ADDENDUM# 2

DOOR REPLACEMENT AT 3 SCHOOLS
 (CONARD, SEDGWICK, AND WEBSTER HILL)
 Bid # 200032

May 7, 2020

Drawing DA4, DETAIL 3:

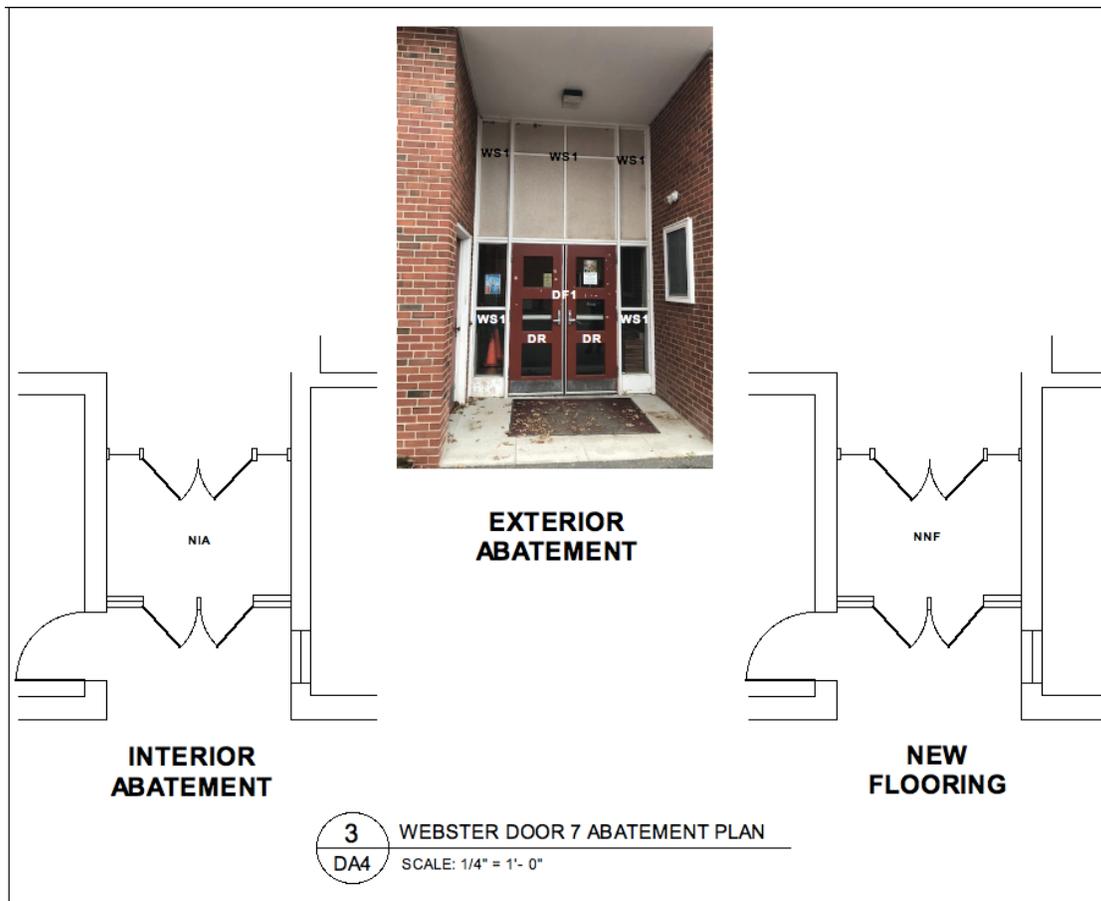
Delete the removal of vinyl asbestos floor tile and the installation of new VCT at the Door 7 foyer area – the existing flooring in the foyer area is stone. See revised Detail 3 below.

Drawing DA1, DETAIL 1:

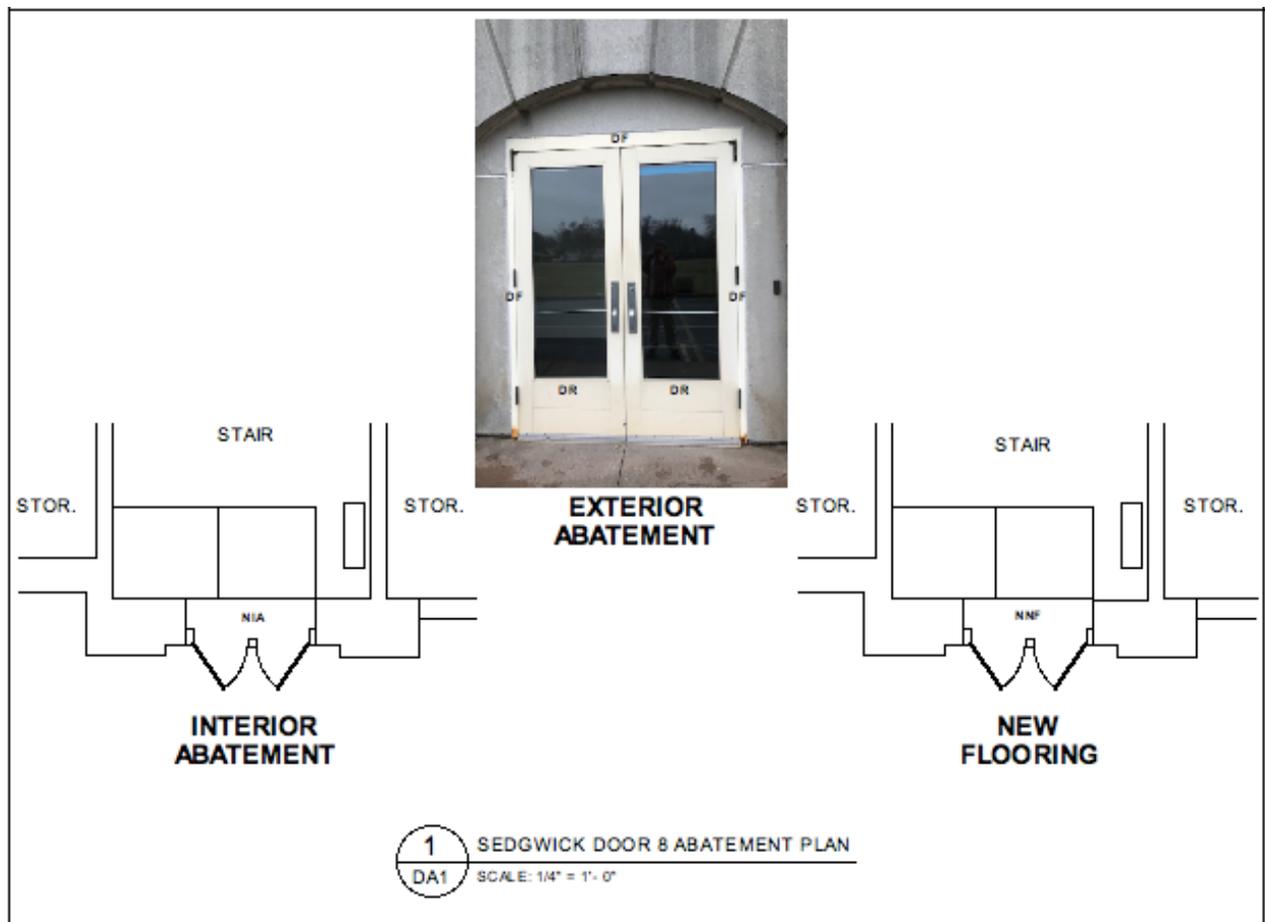
Delete the removal of vinyl asbestos floor tile and the installation of new VCT at the Door 8 threshold area – the existing flooring in the threshold area is concrete. See revised Detail 1 below.

Drawing DA3, DETAIL 3:

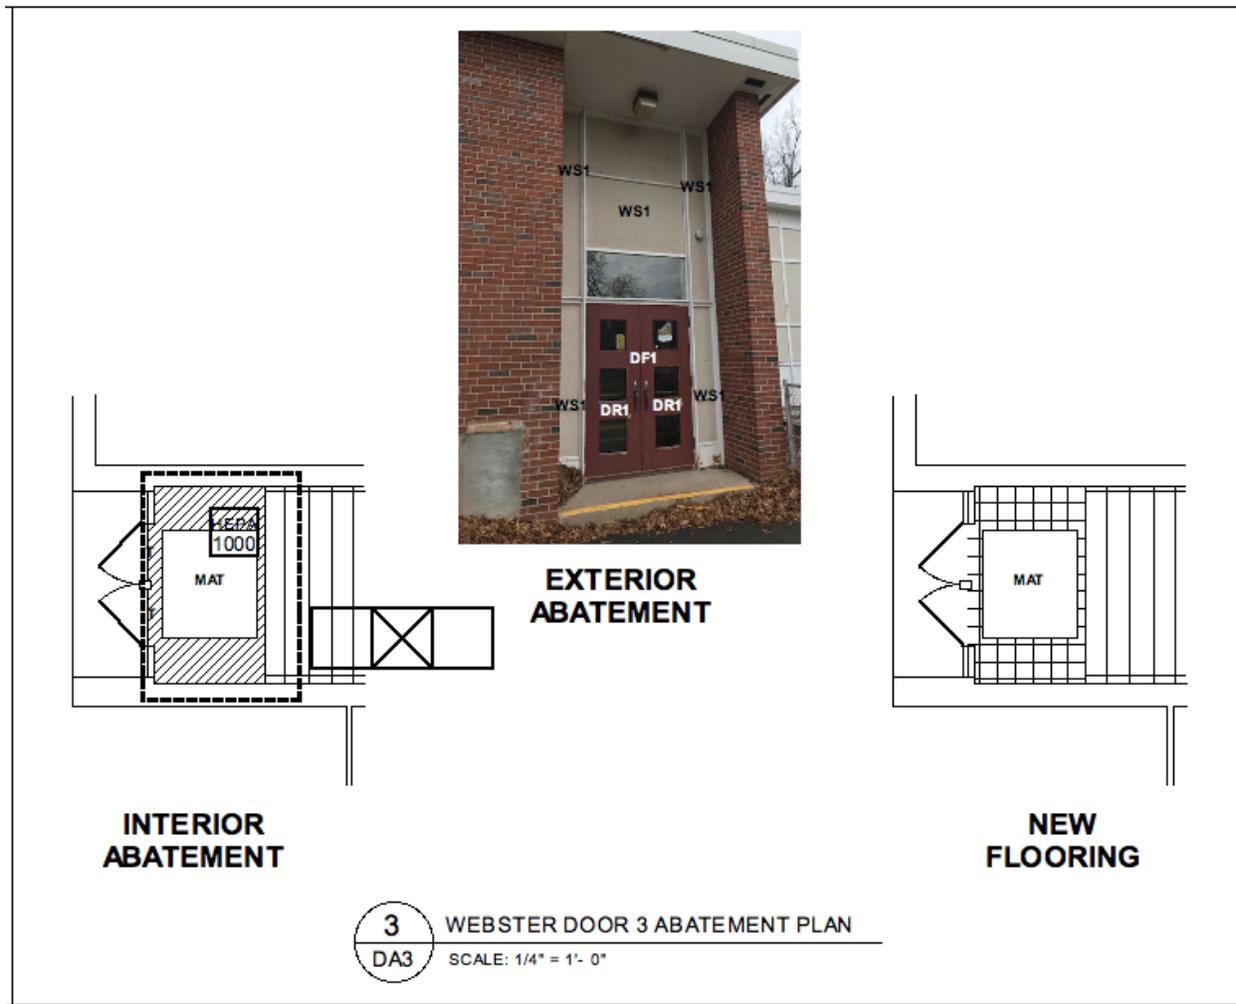
A rubber floor mat is present in the Door 3 foyer abatement area and has been added to Detail 3 below.
